Access Compliance Report

Public Rights-of-Way

(Curb Ramps)

Intersection ID: 48945	Main Street: DAVID_JENNINGS_AV	Cross Street: CALDWELL_RIDGE_PY	Location: E
ADA ID: F861F7B4EB3F	Ramp Type: Perp	Initial Pass/Fail: Pass	Overall Compliance: No
Severity Score: 5			
Codes/Mitigation Info/Possible Solution		Field Measurements/Component Compliance

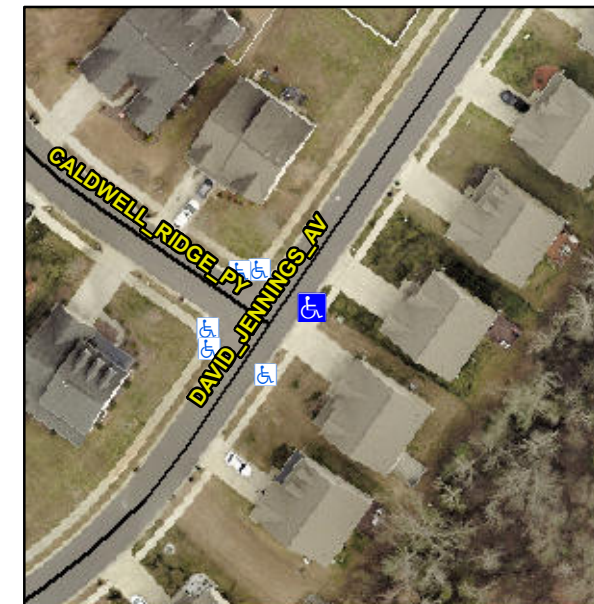
Not Found, R305.2, R302.7, R304.5.4

Compliance	Description	Data	Compliance	Description	Data
N/A	Ramp Length (in)	47.5	Yes	Ramp Slope (%)	5.2
Yes	Ramp Width (in)	48.0	Yes	Ramp XSlope (%)	0.4
N/A	Flare Type LT	Sloped	N/A	Flare Type RT	N/A
N/A	Flare Slope LT (%)	0.7	Yes	Flare Slope RT (%)	4.4
N/A	Flare Traversable LT?	No	N/A	Flare Traversable RT?	Yes
Yes	Landing Length (in)	48.0	Yes	DWS Provided?	Yes
Yes	Landing Width (in)	48.0	Yes	DWS Contrast?	Yes
Yes	Landing Slope (%)	1.9	Yes	DWS Length (in)	24.0
Yes	Landing X Slope (%)	0.0	Yes	DWS Full Width?	Yes
N/A	Landing Curb? (Y/N)	No	No	DWS Offset (in)	3.5
N/A	Shared Landing?	No			
No	Gutter Ponding?	Yes	No	Gutter Slope (%)	7.2
Yes	Gutter Lip Ht (in)	0.0	Yes	Gutter X Slope (%)	0.5
N/A	Painted X Walk1?	No	N/A	Painted X Walk2?	N/A
	X Walk 1 Direction	To NW		X Walk 2 Direction	N/A
N/A	X Walk 1 Width (in)	N/A	N/A	X Walk 2 Width (in)	N/A
	X Walk 1 Slope (%)	2.8		X Walk 2 Slope (%)	N/A
	X Walk 1 X Slope (%)	0.8		X Walk 2 X Slope (%)	N/A

N/A	Ramp inside XWalk1?	N/A	N/A	Ramp inside XWalk2?	N/A
	Road Slope (%)	N/A	N/A	Clear Space?	Yes
	Road X Slope (%)	N/A	N/A	Clear Space to XWalk (in)	N/A
Yes	Any Obstructions?	No	Yes	Storm Grate/Utility Hazard?	No
	Obstruction Type			Storm Grate/Utility Type	
		N/A			N/A
			Yes	Surface Condition? (G/P)	Good

Remove & Replace Entire Ramp.
Remove & Replace Gutter.
